**November 2017
FL741A
NHTSA #17V-451
REVISED NOTICE**

Subject: FCCC XCR Chassis Battery Cables

**Models Affected: Specific Freightliner Custom Chassis
XCR chassis manufactured November 27, 2012, through
February 23, 2016.**

Fig. 1, Battery Cable Bracket, Correct Installation

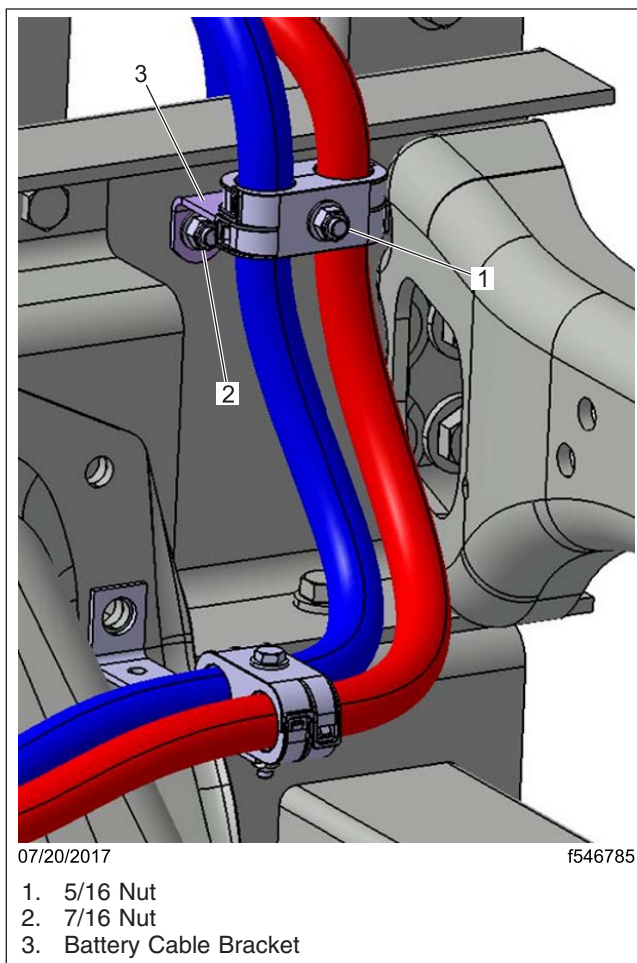
On certain vehicles a battery cable mounting bracket may have been incorrectly installed causing the battery cable to be improperly routed. If improperly routed, the battery cable may come in close proximity to the frame rail and cause rubbing or shorting of the cable. A potential battery cable short between the cable and the frame rail may increase the risk of a fire.

1. Remove the 5/16 nut and washer from the portion of the bracket holding the battery cables and set the nut and washer aside.
2. Loosen the 7/16 nut that attaches the battery cable bracket to the frame rail and correctly rotate the bracket as shown in [Fig. 1](#).
3. If the battery cable bracket is missing, install it on the frame rail using the 7/16 nut and washer assembly. See [Fig. 1](#) for proper installation.

4. Tighten the 7/16 nut and washer assembly 42 lbf·ft (57 N·m).

Fig. 2, Battery Cables Rubbing the Frame Rail

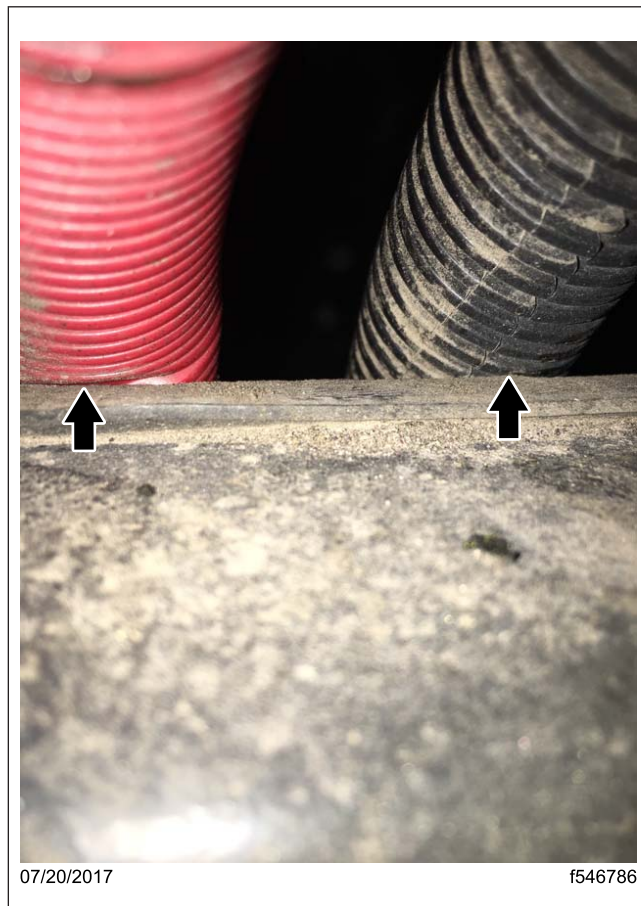
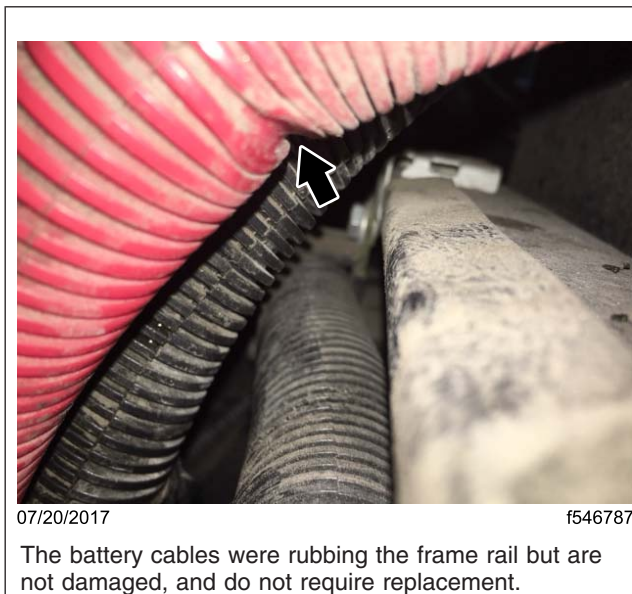
- If the battery cable bracket is incorrectly installed or missing, inspect the battery cables for damage. It is possible for the conduit that covers the cable to be damaged, but the battery cables are not damaged. Damage to the battery cables could include, but is not limited to, a cut in the battery cable or visible cable insulation. See [Fig. 2](#) and [Fig. 3](#). After inspection of the battery cable, go to 'Battery Cable Bracket Procedure.'

IMPORTANT: If the battery cable(s) are damaged, replace the battery cable(s). It is possible for the conduit that covers the cable to be damaged, but the battery cables are not damaged. Damage to the battery cables could include, but is not limited to, a cut in the battery cable or visible cable insulation. See [Fig. 2](#) and [Fig. 3](#)
